Falmouth Docks Development: Appropriate Assessment Addendum – Fal and Helford SAC

Project name **Falmouth Docks Development**
Project no. **1620015743-006**
Client **A&P Group**

Date 13/10/2025

This AA Addendum addresses the following specific points raised by Natural England regarding detailed advice (Ref: 519879, 08 September 2025) on the HRA for impacts to support a conclusion of no Adverse Effect on Integrity (AEoI) on the Fal and Helford SAC:

Figure 7 – Proposed Dredge Areas in Relation to Areas of Maerl Habitat, Categorised as Living Maerl overlying Dead Maerl or Areas of Maerl in Sediment

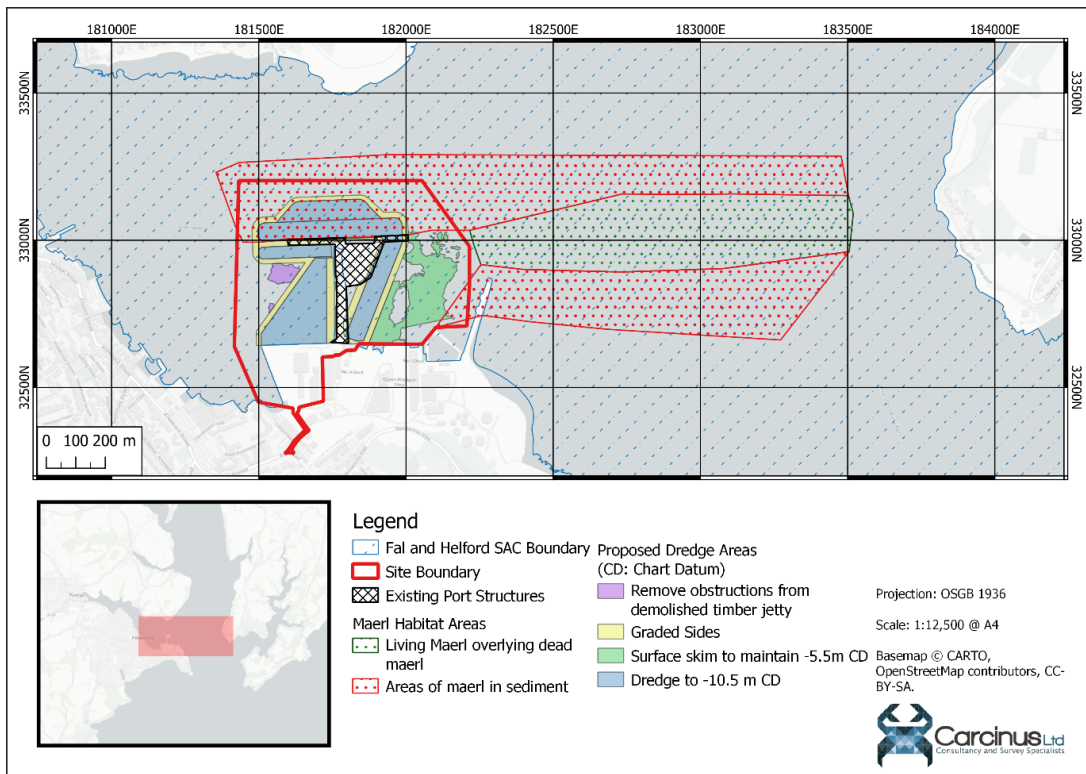
The survey data identified habitat types thought to be consistent with two of the descriptions above: living maerl overlying dead maerl and areas of maerl in sediment. These two habitat types are mapped and overlaid with the red line boundary (Figure 7). As there are no criteria for these descriptions there was not an opportunity to present a greater resolution within these two maerl habitat and thus some of the discrimination relies on the mapping shown in Figures 4-6 above.

Figure 8 - Sediment deposition (mm) at the end of the entire dredging campaign as a result of proposed dredging operations

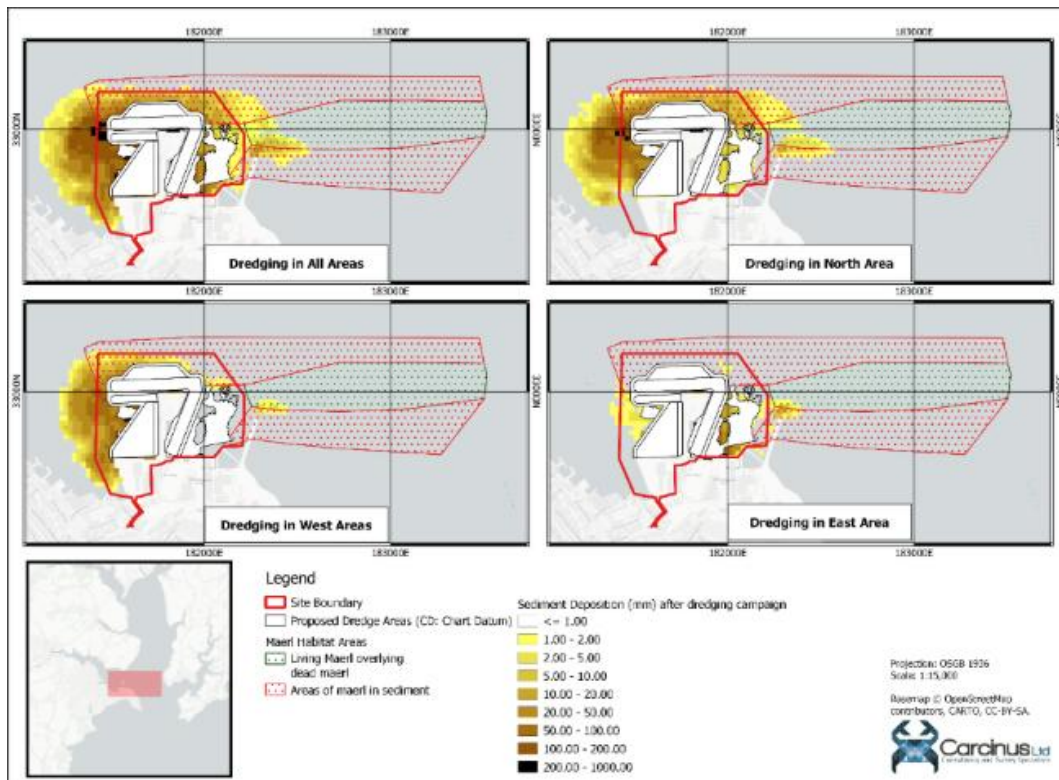
For both increased SSC and deposition the area of effect is predominantly within the project red line boundary, with some small areas to the north and east outside of the boundary. Modelled impacts show very limited zones of influence – as seen in Figure 8 of predicted sediment deposition from the entire dredge campaign, assuming no break in operations between the three dredge pockets.

Figure 10 - Maximum increase in suspended sediment concentrations resulting from proposed dredging operations in each of the three areas

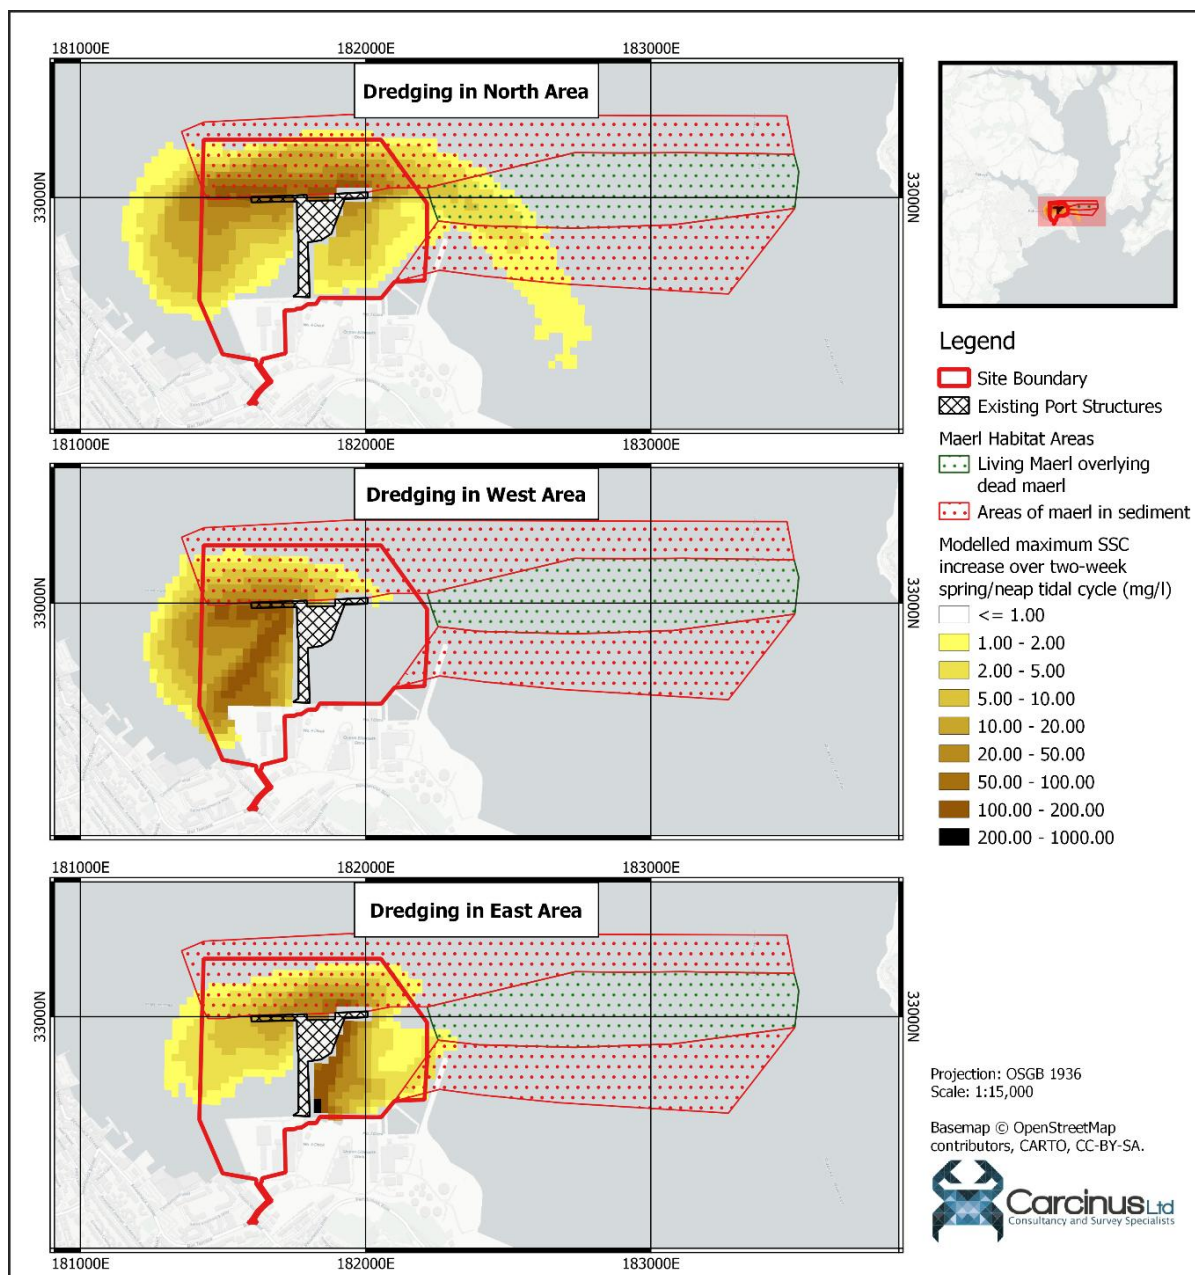
The modelling results for increases in SSC were mapped showing the maximum increase in suspended sediment concentrations resulting from proposed dredging operations in each of the three areas (Figure 10). With the exception of the dredge campaign in the north area, increases in SSC are largely contained within the docks.

Despite the fact that there would therefore be a daily spike in SSC during that time, the maximum increases in SSC at all modelled receptor locations are not higher than periodic storm events and average SSC values are within the ambient range. The restriction of dredging to certain tidal states significantly minimises the spatial extent of this plume, and SSC peak values are expected to be within natural variation. Sediment plumes are limited to within 300 m of the dredged area and are, on average, largely confined to the area within the site boundary. Where the plume extends beyond the site boundary the concentration modelled is very low (Figure 10, Dredging in North Area panel).

However, these contour plots can be misleading as they appear to represent an actual plume, when in reality the figure shows the maximum values that can occur across the whole dredge programme, not what occurs every time dredging takes place or what occurs all of the time.

Figure 12 – Time series of predicted increase in suspended sediment concentration, for all nine receptor sites. Dredging in the north of the site

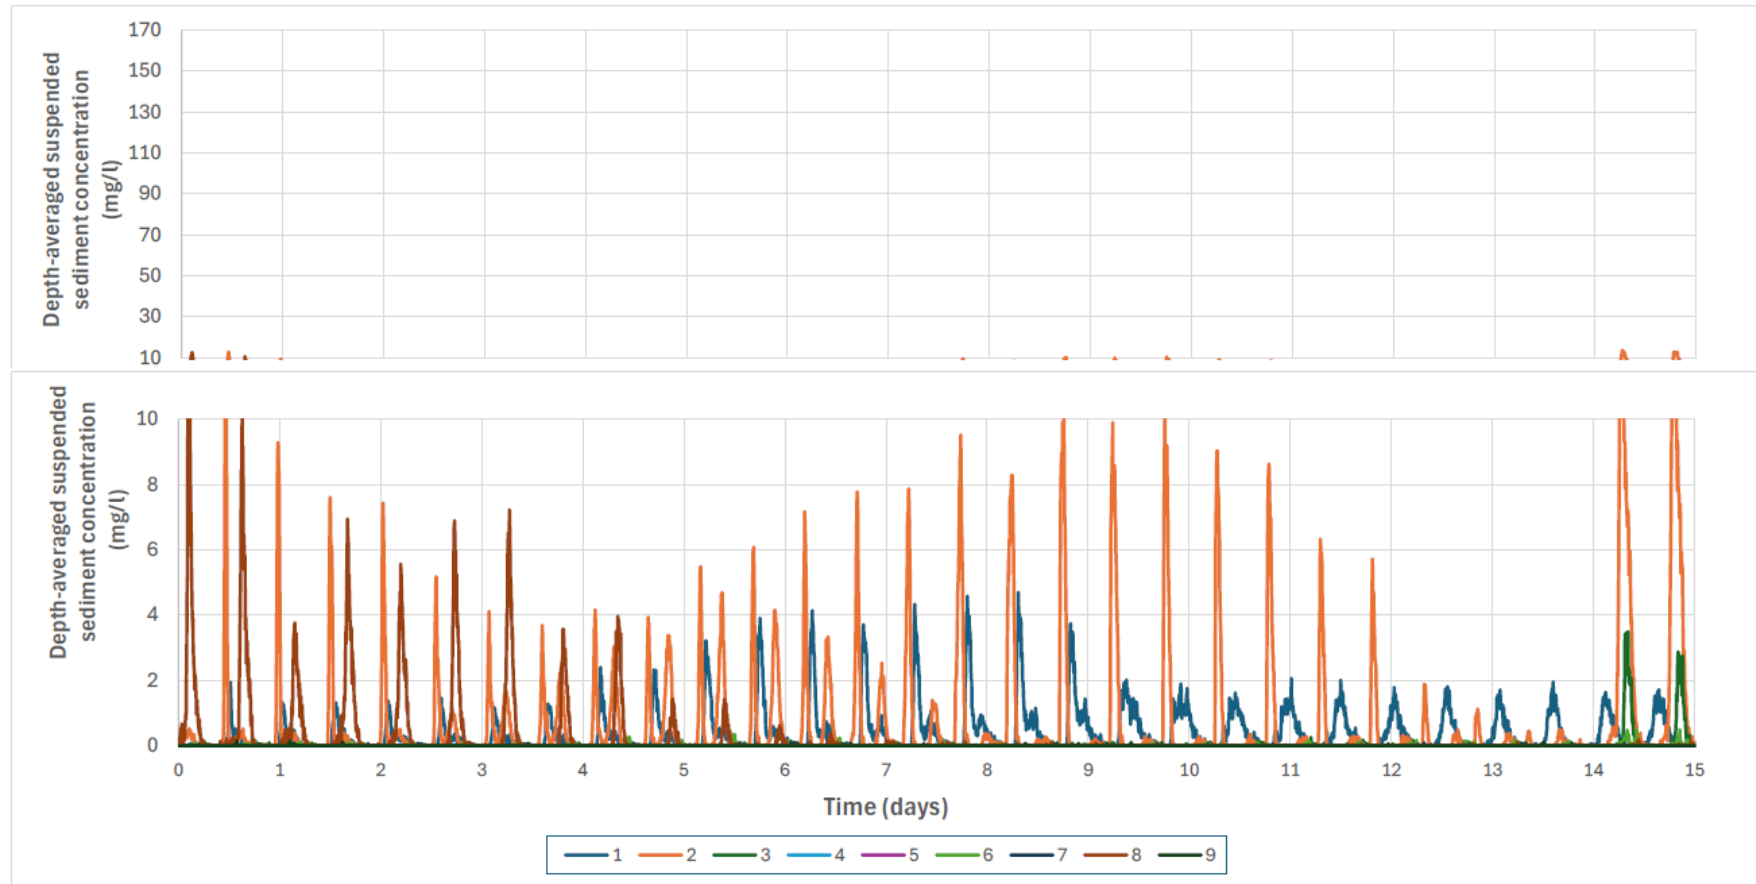
Three time-series figures, one for each of the dredge areas were provided in Technical Appendix 6.3, which was submitted with the application, but they were not specifically presented in the HRA report. As an example, the time-series for SSC from dredging in the northern area (the worst-case area) is shown in Figure 12.

Note that in the original timeseries, right at the end of the timeseries (after 14.5 days of dredging) the model erroneously switched to being all tide, showing artificial high peaks at the end of the plot in Figure 12. The location specific plots in Figure 13 to Figure 15 have therefore been stopped at 14.2 days.

Figure 13 - Location 2 showing SSC time-series for dredging in west (top), north (middle) and east (bottom) over a 2-week spring-neaps tidal cycle

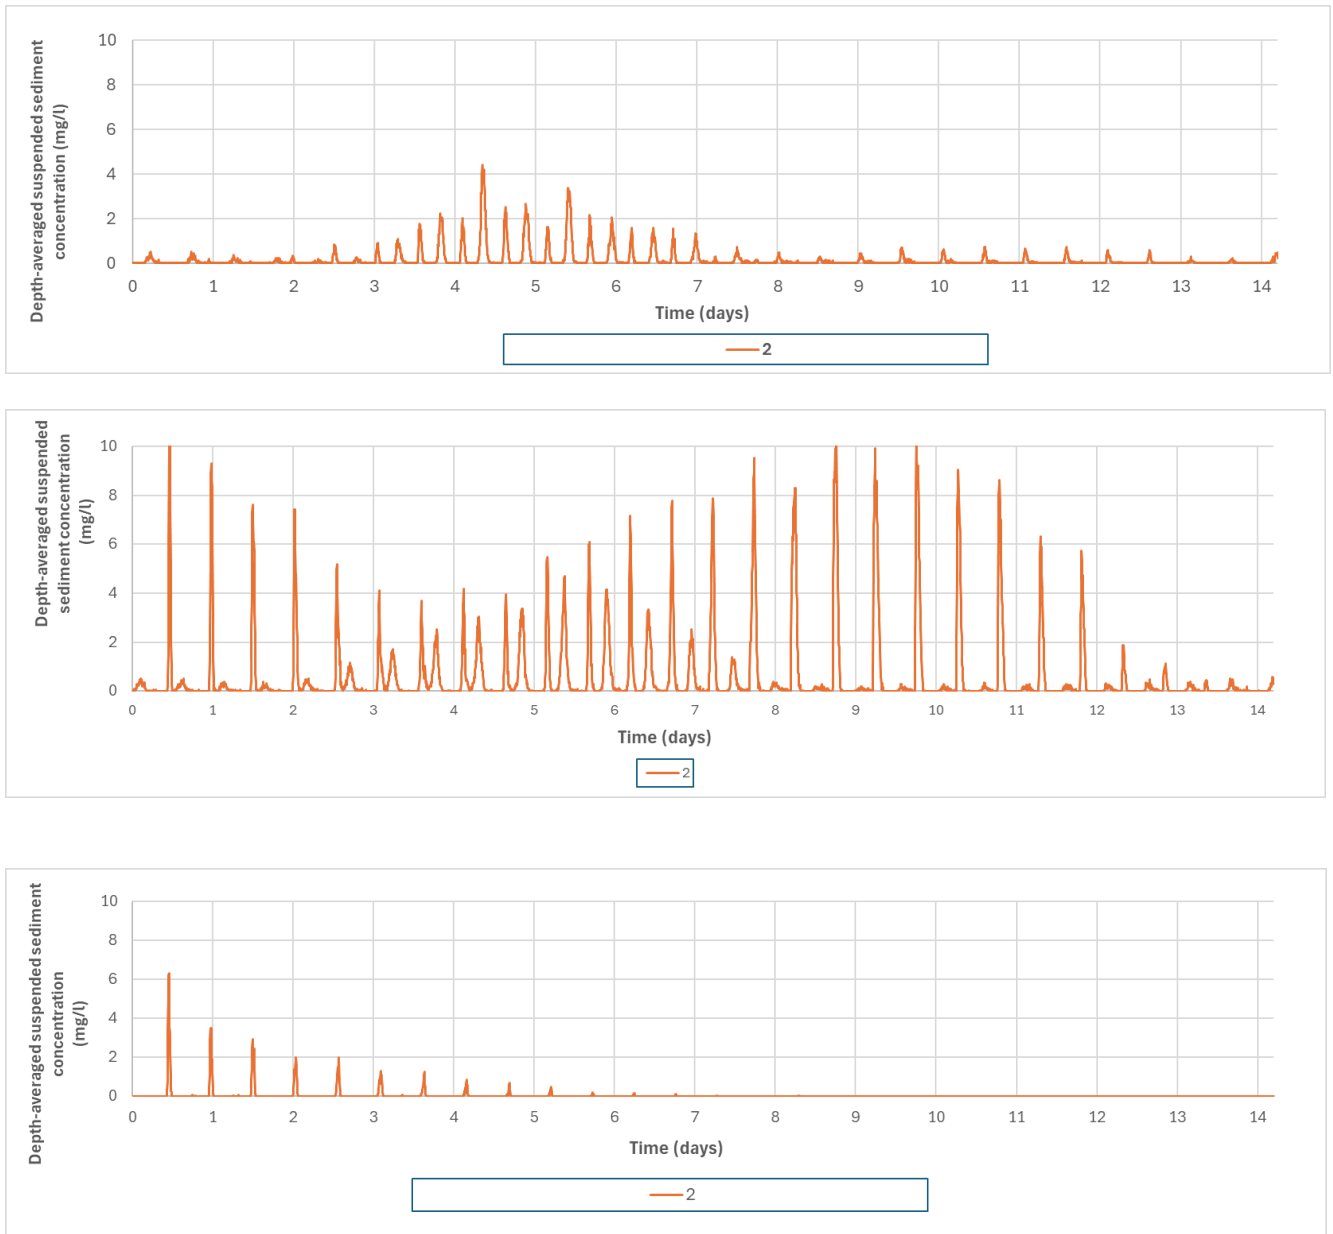
Site 2, immediately to the north of the northern berth pocket but within the site boundary has SSC values up to just over 10 mg/l (Figure 13) but only during part of the tidal cycle and the plots show the peaks are short-lived, rapidly returning to baseline.

Figure 14 - Location 3 showing SSC time-series for dredging in west (top), north (middle) and east (bottom) over a 2-week spring-neaps tidal cycle

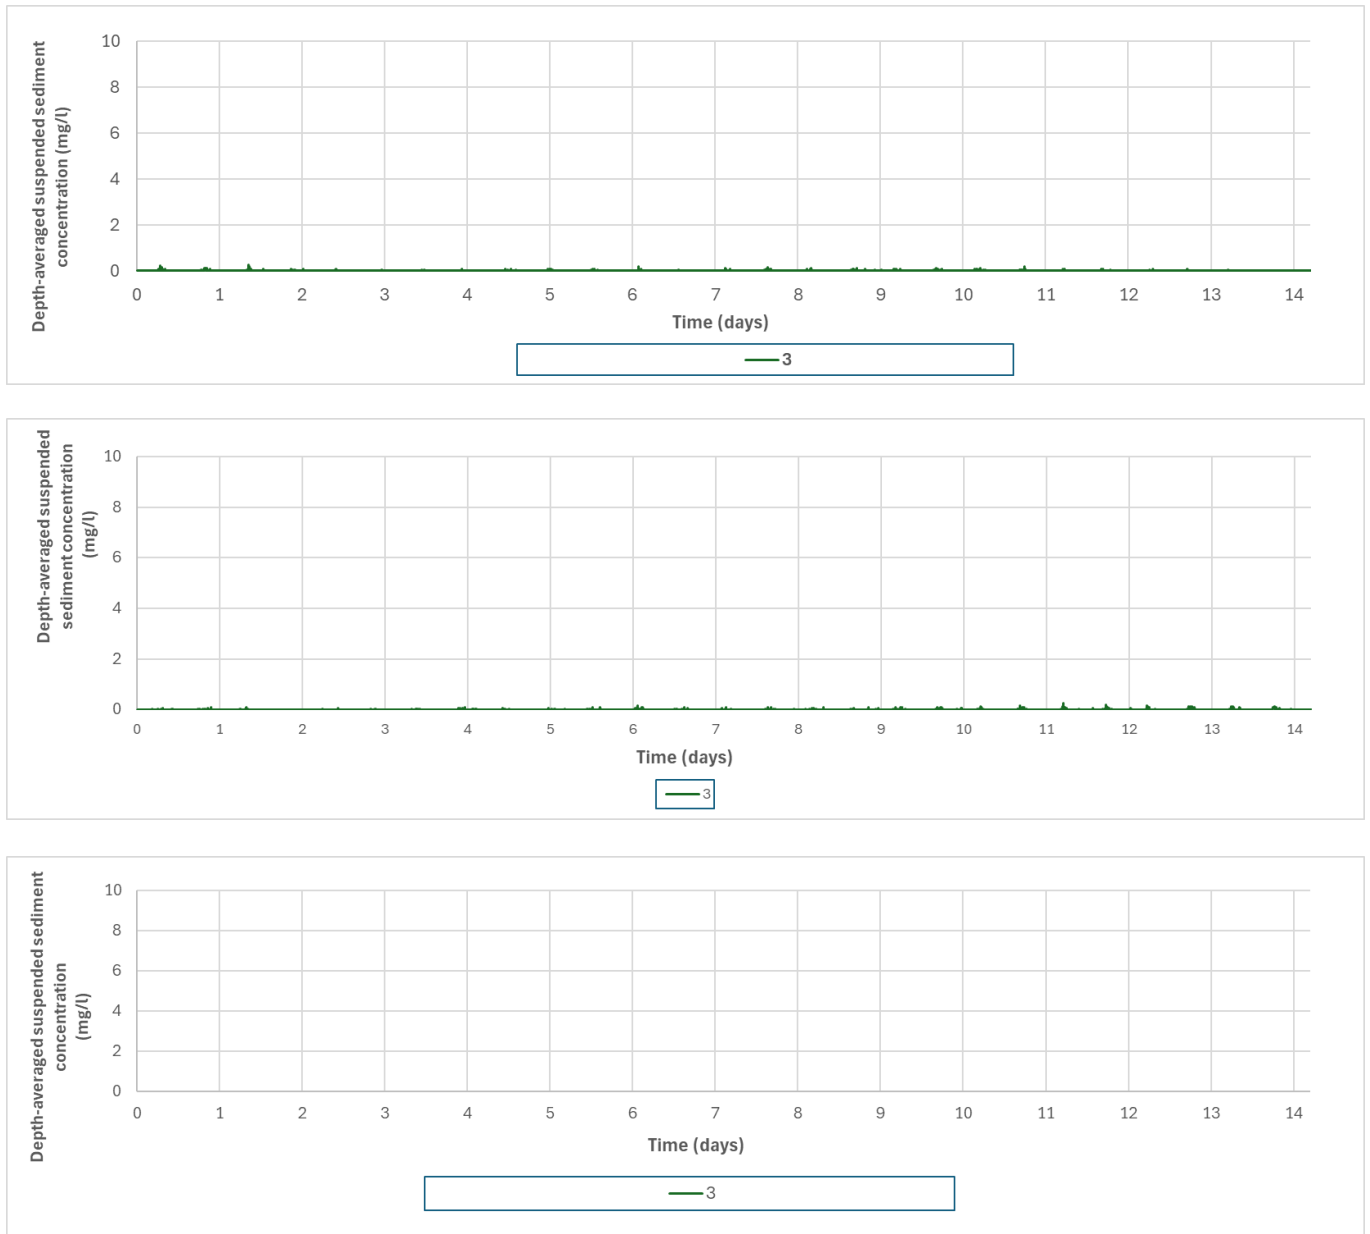
Site 3, within the area of maerl that was mapped as 'live maerl over dead maerl' also has a very low increase in SSC across the whole tidal cycle, indicative of the effectiveness of the tidal restriction mitigation measure (Figure 14).

Figure 15 – Location 5 showing SSC time-series for dredging in west (top), north (middle) and east (bottom) over a 2-week spring-neaps tidal cycle

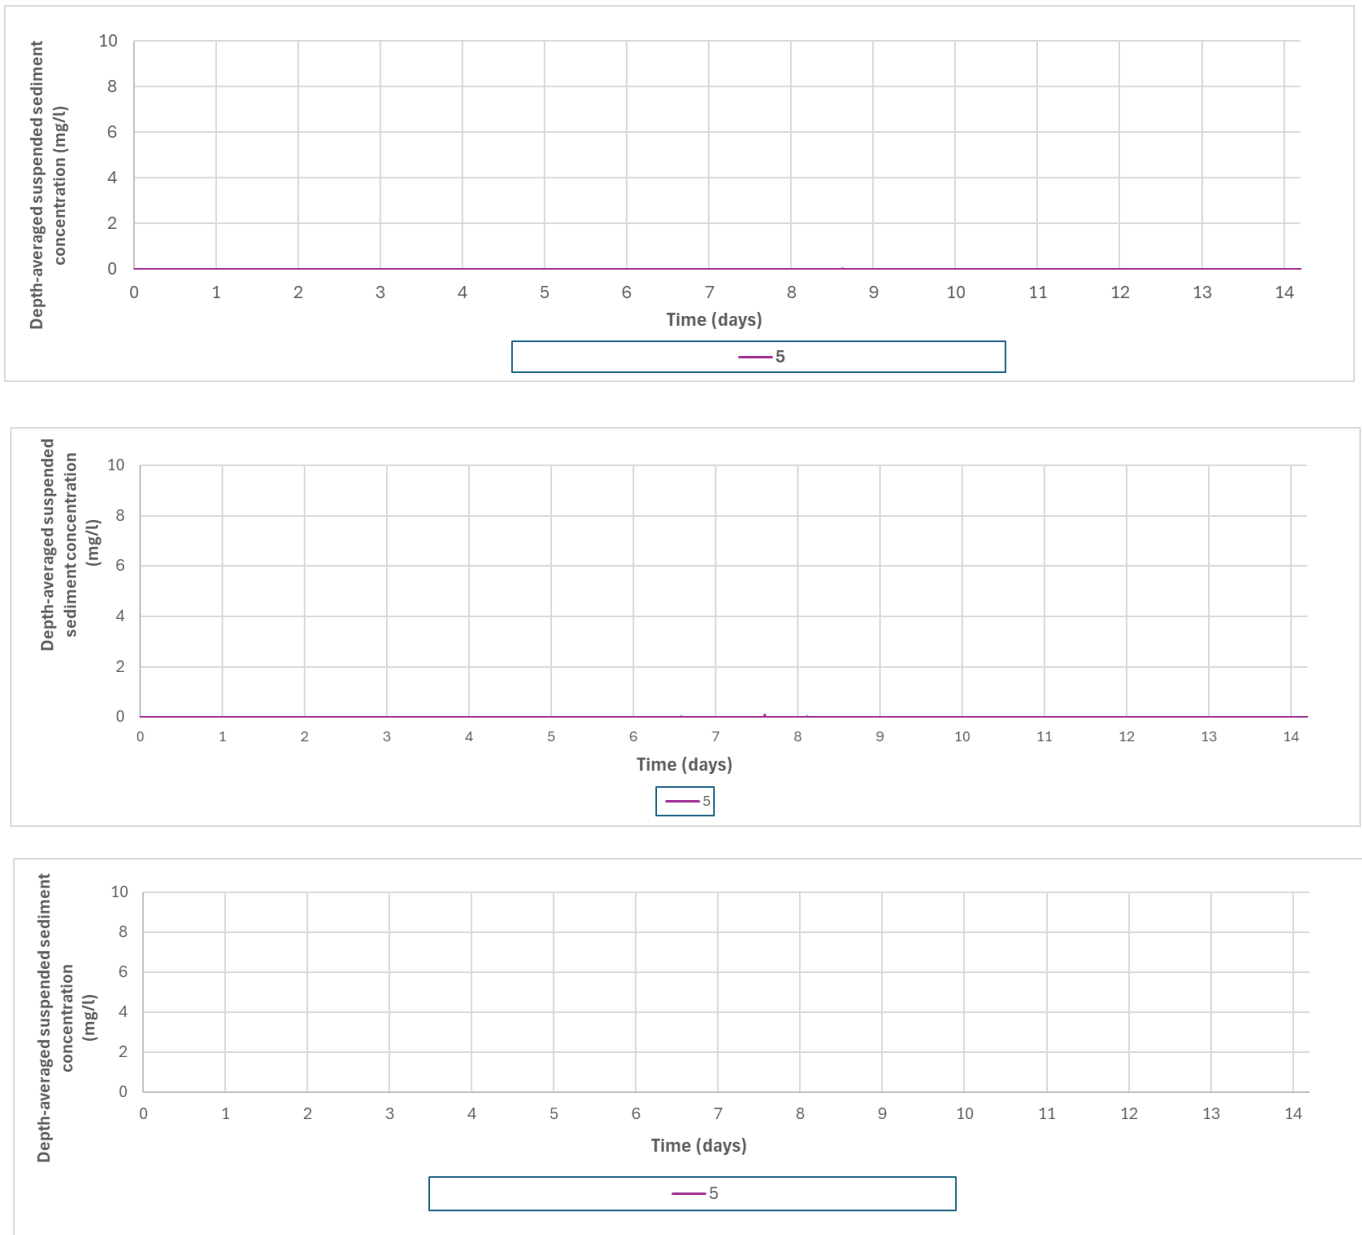
At Site 5 the maximum SSC was <0.1 mg/l, including from dredging in the north area (Figure 15), and thus the seagrass beds at Flushing were beyond the ZOI for SSC and no further assessment of this habitat is required.
